Number: TSB-FC-2015-038 SC6500 Pinch Point

Symptom: Potential pinch point on recovery tank near latch bracket

Date: Date: 30th Oct. 2015

Fig.1 Old design BRACKET-LATCH

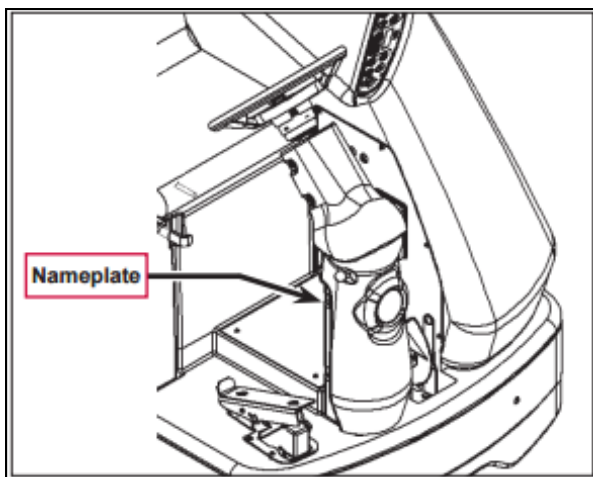
When opening or closing the recovery tank, the operator could potentially pinch their hand or fingers. [See Fig. 1]

Variation in the rotomolded tank can create a possible pinch between the latch bracket and the recovery tank.

The bracket has been redesigned to prevent this from possibly occurring. [See Fig. 2]

Replace the old design BRACKET-LATCH with the newly redesigned one if there is not enough clearance.

56414118 BRACKET-LATCH to increase space between tank and bracket to prevent potential pinch point
